TO: Alice Burnett
FROM: Simon de Verteuil, Senior Transport Engineer
PROJECT REF: 033020

PLAN CHANGE 74 (HUGHES DEVELOPMENT LIMITED) RESPONSE TO REQUEST FOR FURTHER INFORMATION: TRAFFIC ASSESSMENT

Figure 3: Existing Speed Limit Change and Threshold Treatment along Halkett Road (view north of the Proposed Site Access).

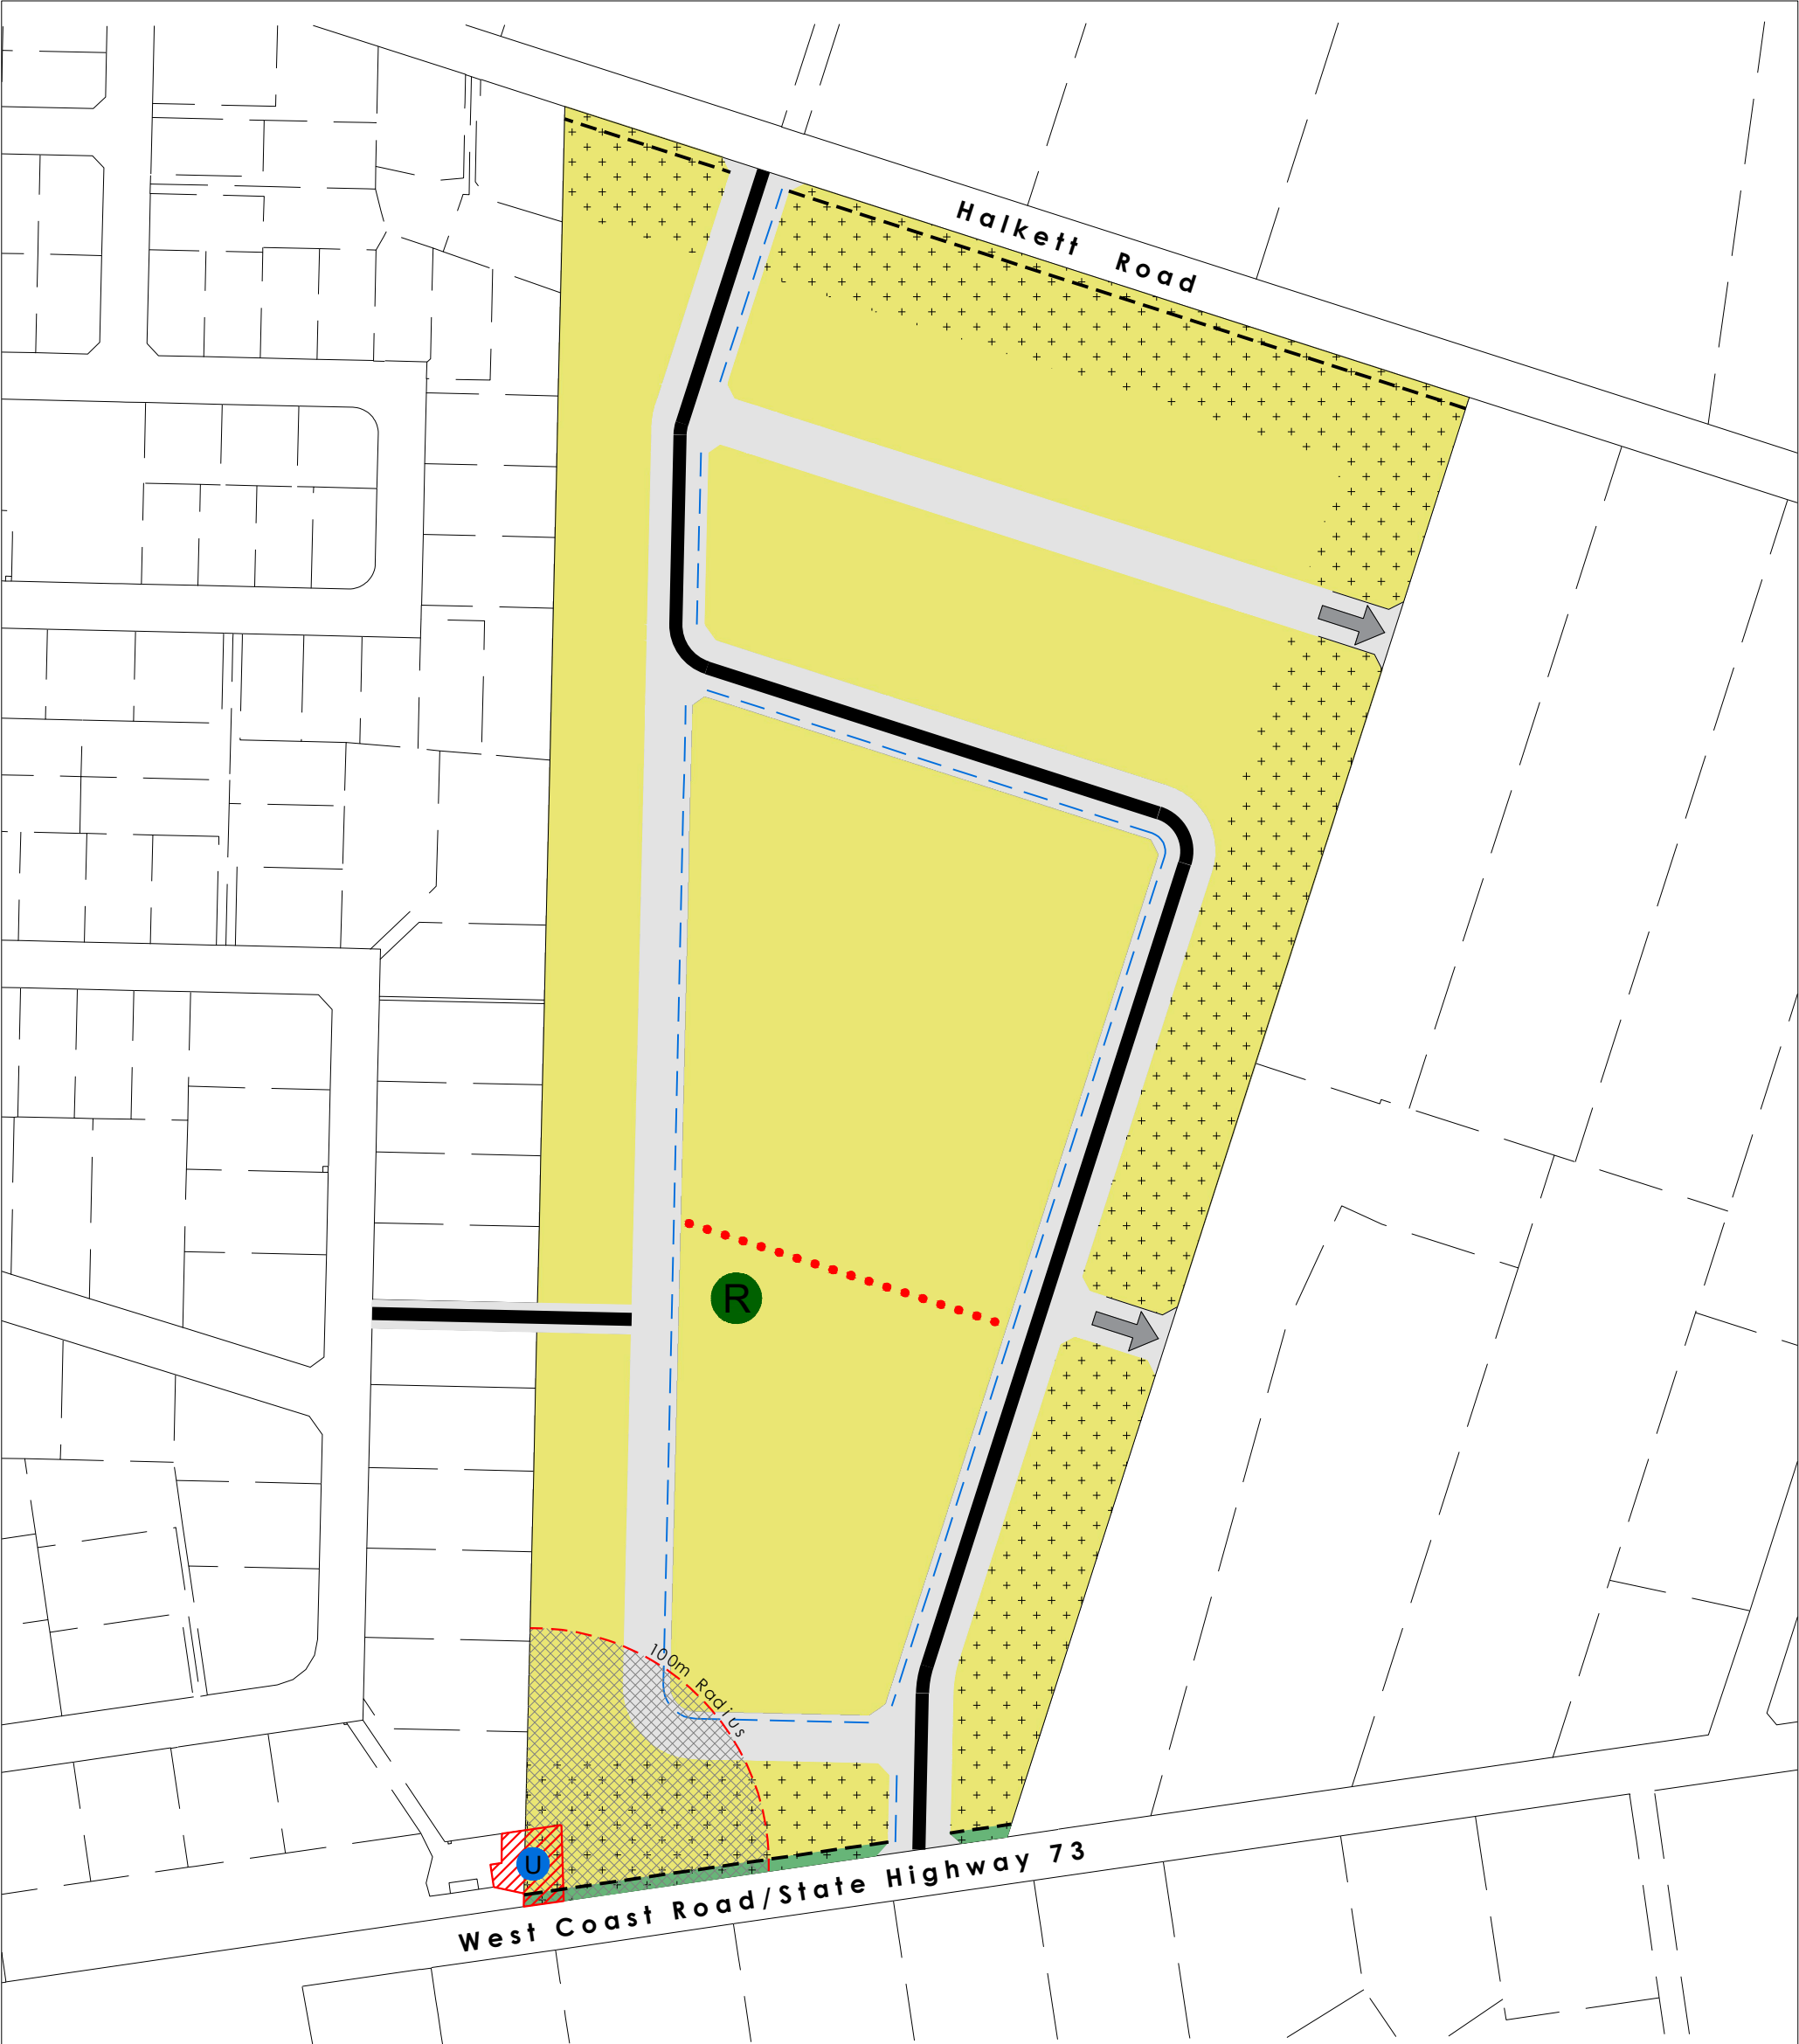
19. **Question 14 h:** *There is proposed to be no direct property access to Halkett Rd, which is out of keeping with that west to Weedons Ross Road. This would mean all of the proposed development would be inward facing. The ability to extend the existing speed limit on Halkett Road would also be compromised to encompass the new intersection. It is noted that the existing speed threshold is located where the proposed ODP intersection is proposed.*

23. If direct property access is preferred by Council, there would be some merit in reducing the speed limit along Halkett Road along the full frontage of the site. The existing speed threshold (see **Figure 3**) would need to be relocated to the east of the site.

24. The proposed ODP intersection will be positioned at an adequate distance from the existing speed threshold treatment at the time of preliminary design so as to avoid any conflict. If the speed threshold treatment does impact on the location of the OPD intersection, then the applicant will work with the Council to relocate the speed threshold to a suitable location in proximity to the site. This may be east or west along Halkett Road.
